| Project | IEEE 802.16 Broadband Wireless Access Working Group < http://ieee802.org/16 > | |
| Title | Proposed AWD Text on the Ranging Structures for Non-synchronized AMSs | |
| Re: | IEEE 80216m-09/0020, "Call for Contributions on Project 802.16m Amendment Working Document (AWD) Content" "Comments on AWD 15.3.9 UL-CTRL" | |
| Abstract | This contribution proposes the text of ranging channel section to be included in the IEEE 802.16m AWD. | |

Figure 450 - The ranging channel structures in the time domain

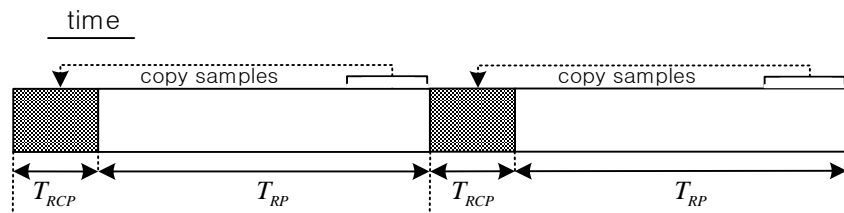
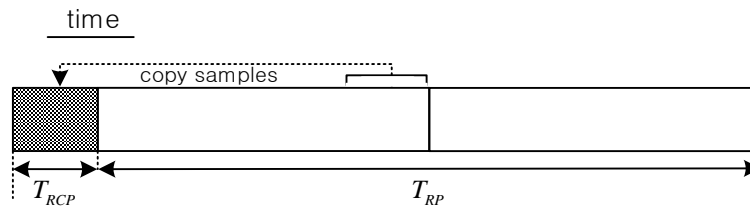
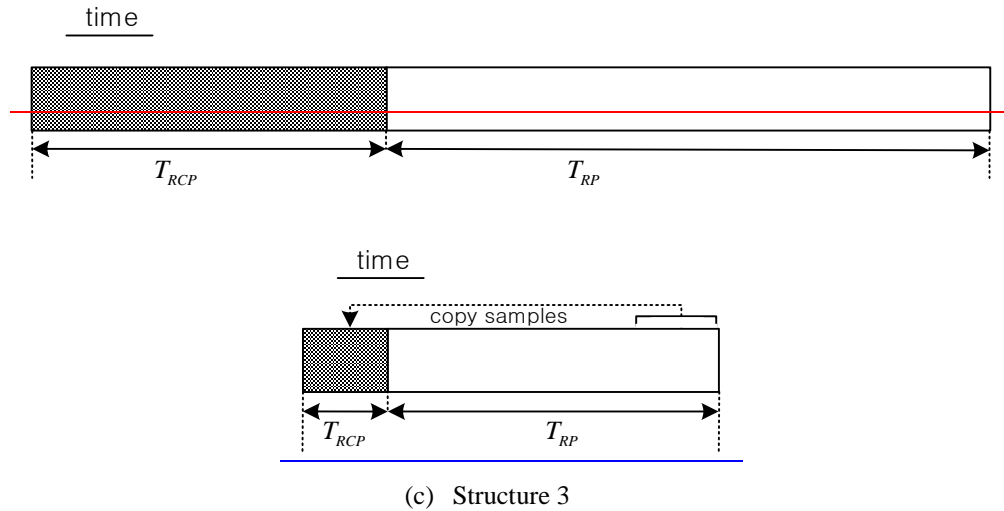
Figure 450 illustrates the ranging channel structures in the time domain.

(a) Structure 1

(b) Structure 2

In the ranging channel Format 0, the repeated RCPs and RPs are used as a single time ranging opportunity within a subframe in Figure 450 (a). Format 1 consists of a single RCP and repeated RPs within a subframe. Format 2 consists of a single RCP and RP which is a part of the Format 0. When Format 1 is used, there are two time opportunities within a subframe. Format 3 has the same structure with Format 1 but its length is different.

| Format No. | Ranging Channel Format Structure | T_{RCP} | T_{RP} | Δf_{RP} |
|------------|----------------------------------|-------------------------------------|--|------------------|
| 0 | Structure 1 | $T_g + k \times T_b$ ^(a) | $2.5 \times T_b$ | $\Delta f / 2.5$ |
| 1 | Structure 23 | | | |
| 2 | Structure 32 | $\alpha + T_g$ ^(b) | $2 \times 2.5 \times T_b$ ^(c) | |
| 3 | Structure 3 | $7 \times T_b + T_g$ | $8 \times T_b$ | $\Delta f / 8$ |
